**ZONING AND PLATTING COMMISSION
HILL COUNTRY ROADWAY
SITE PLAN REVIEW SHEET**

CASE NUMBER: SPC-2017-0513C **ZAP COMMISSION DATE:** November 6, 2018

PROJECT NAME: Holdsworth Center

REQUEST: Variance request is as follows:
 1. Fill exceeding four feet in depth in DWPZ, not to exceed 10
 feet.

EXHIBIT 1

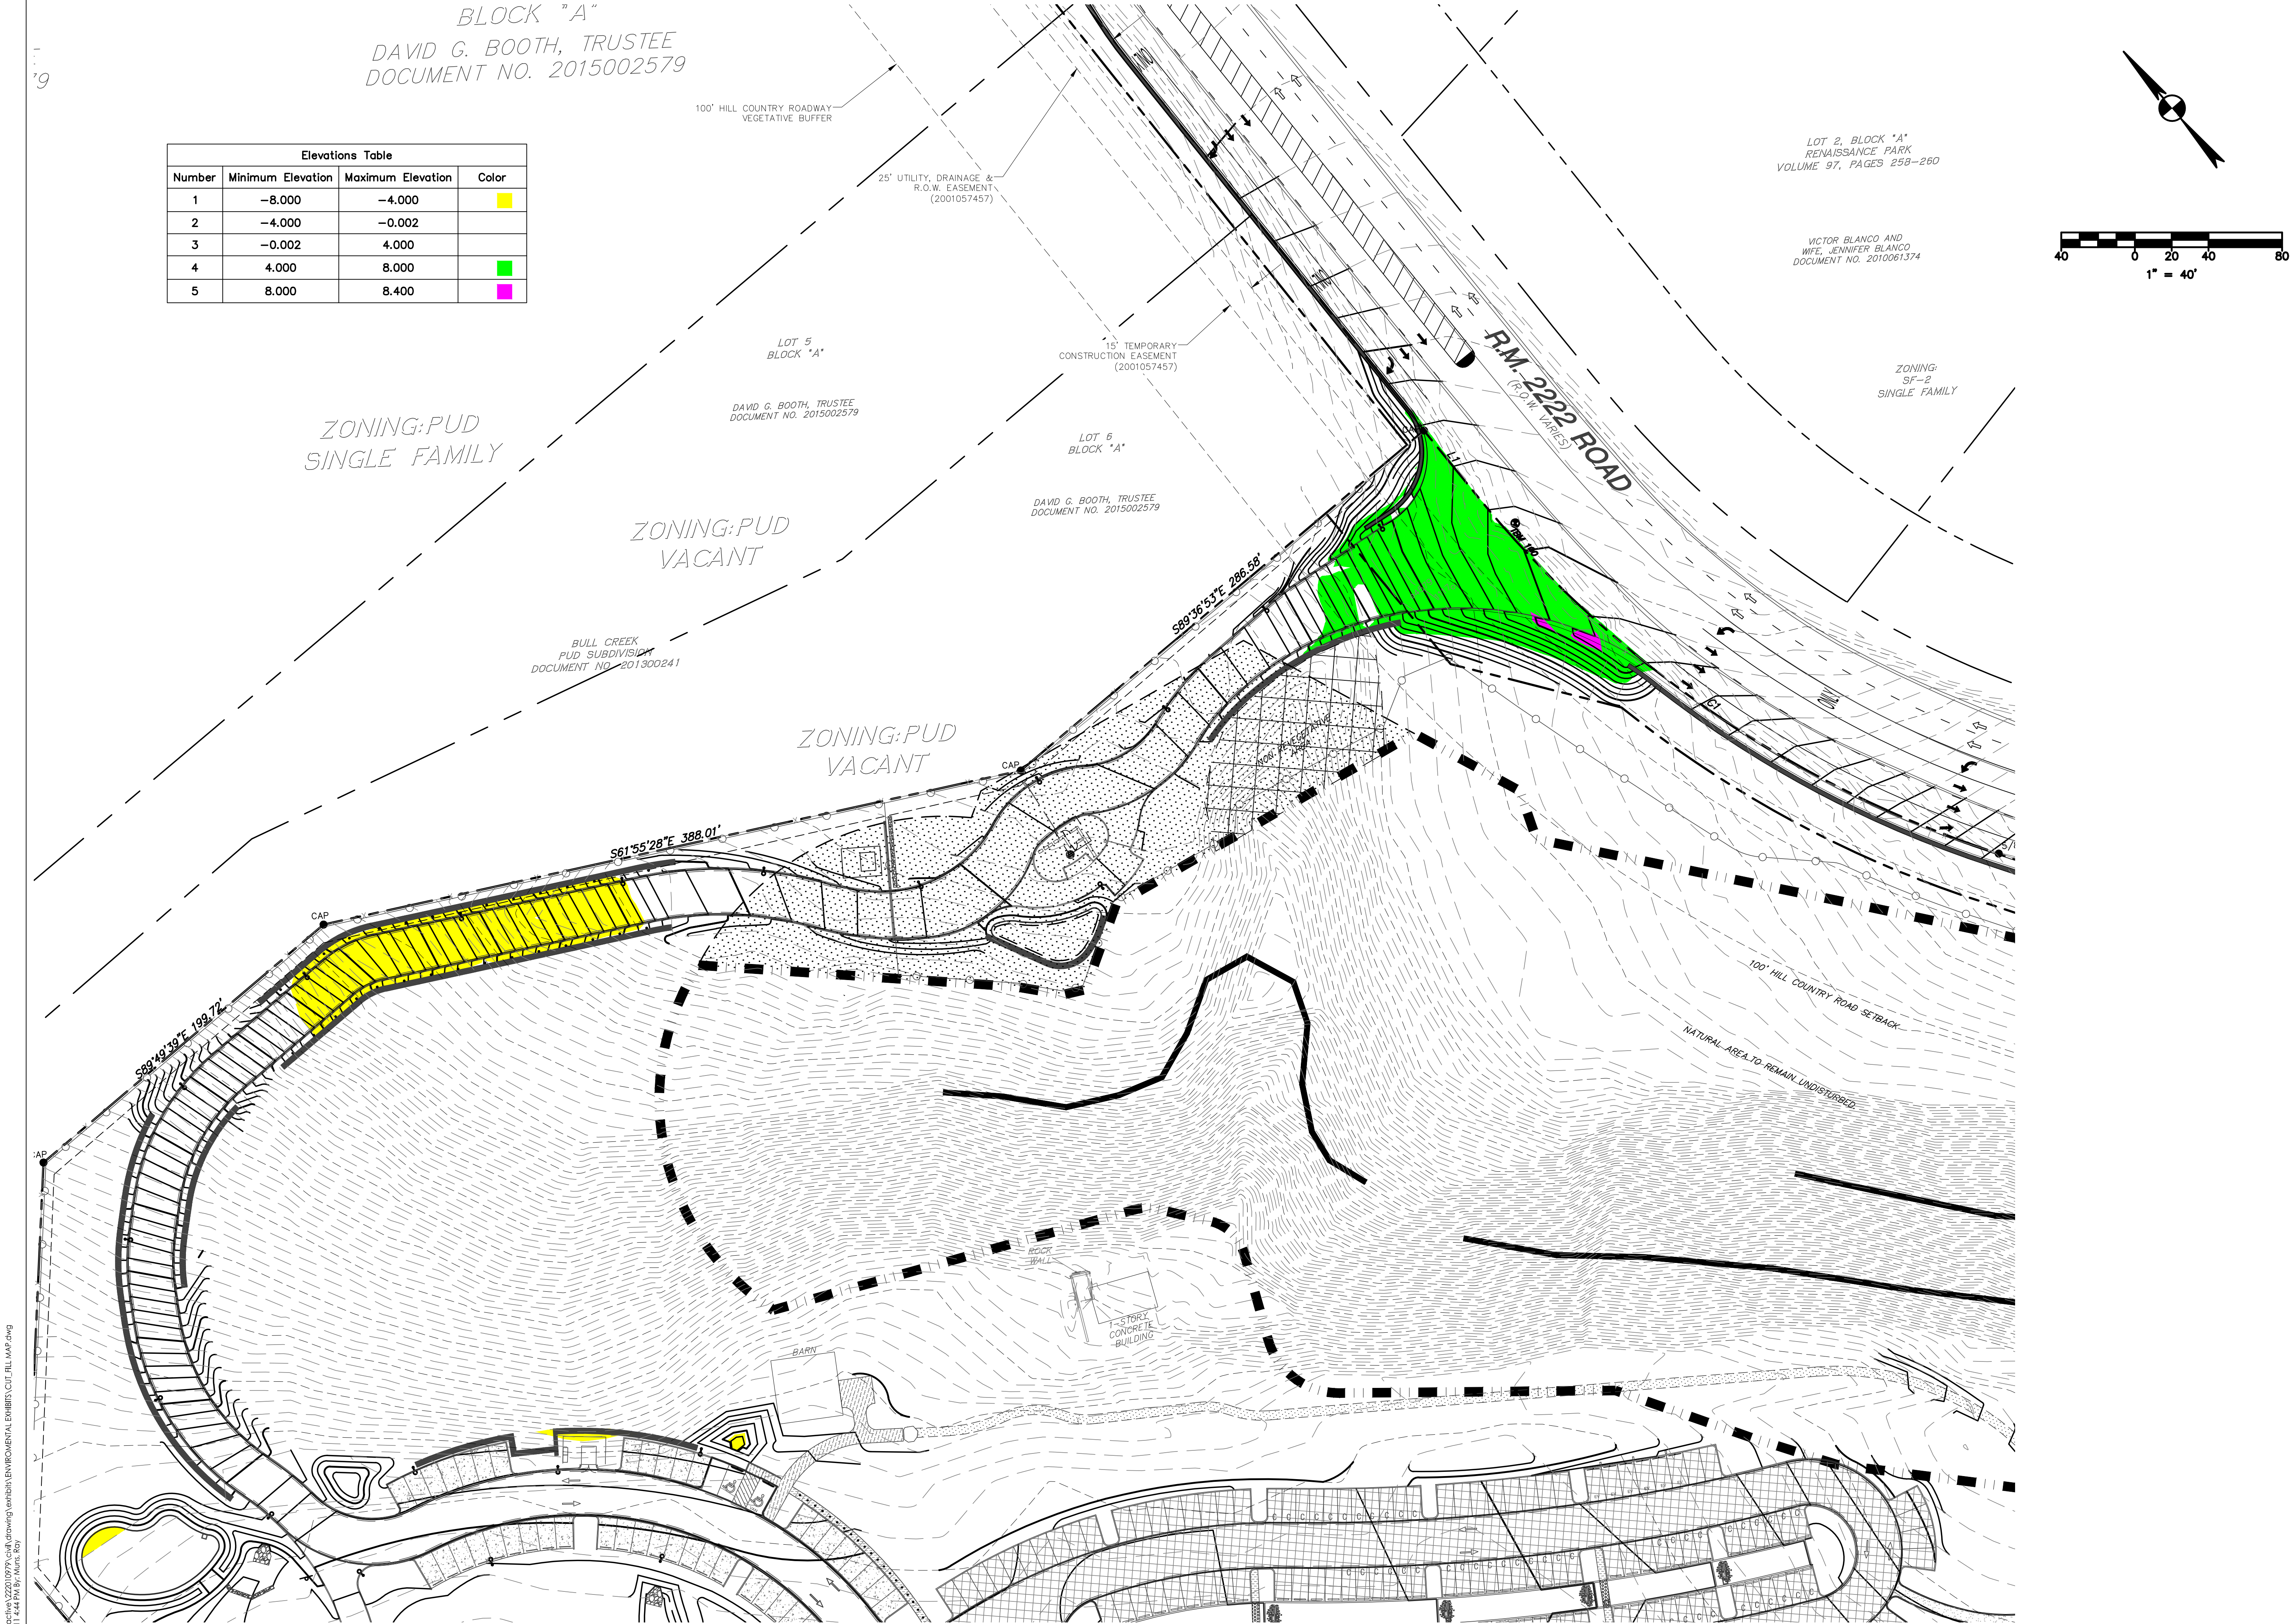
Yes. The entry drive is designed in such a way to reduce the amount of fill required to the least extent possible while still maintaining safe ingress/egress to the site (see Exhibit 1).

Yes. The extra fill is proposed outside the ½ critical root zones of protected trees and will be structurally contained using retaining walls.

- The extra fill must be outside the ½ critical root zones of protected trees and be structurally contained using retaining walls.
- The structural containment must be constructed prior to construction of the fill associated with the need for the variance.
